Subject: Tank No. 2 Red Hill Fuel Facility

Subject: Tower framing Inspection Tank #2

Subject: Review of Cat Walk Framing - Tank #2

**Steel Liner Plate Minimum Thickness Assessment
April 15, 2008**

Photo #5: *Missing bolts*

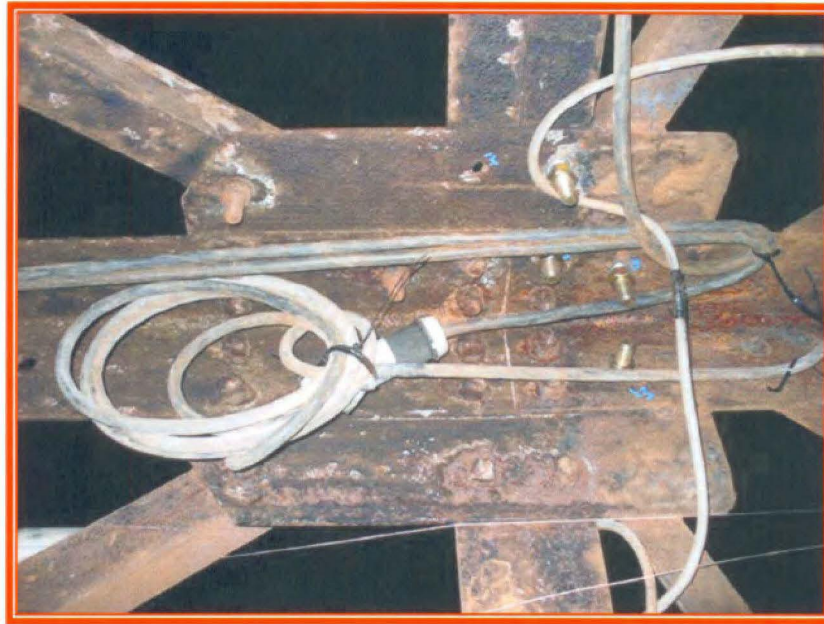
1. Hoist Connection at Top: visible slippages were typically observed on bolt connection. Proper sized washers are recommended to be added. (photo #1, #2)
2. Unused Hoist Connection: Large holes in the vertical legs of the tower which had been drilled for some connection should be covered and welded with plate of same thickness as the tower leg (photo #3 and #4)
3. Missing bolts were observed. Should be installed. (photo #5)

Photo #6: *Bent framing member*

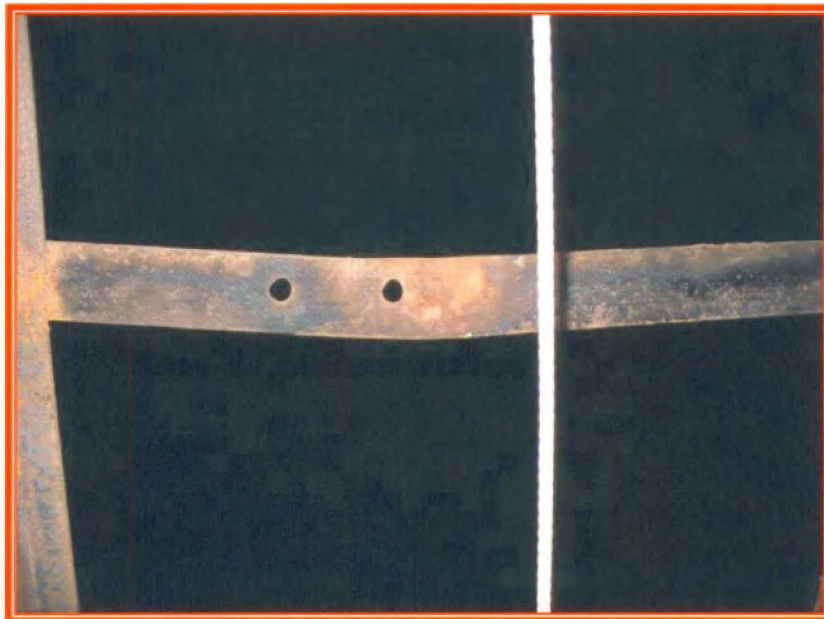
4. Bent framing members were observed. Should be fixed by adding a straight member adjacent to the existing bent member. (photo #6)
5. Missing diagonals were observed. Should be installed. (photo #7)
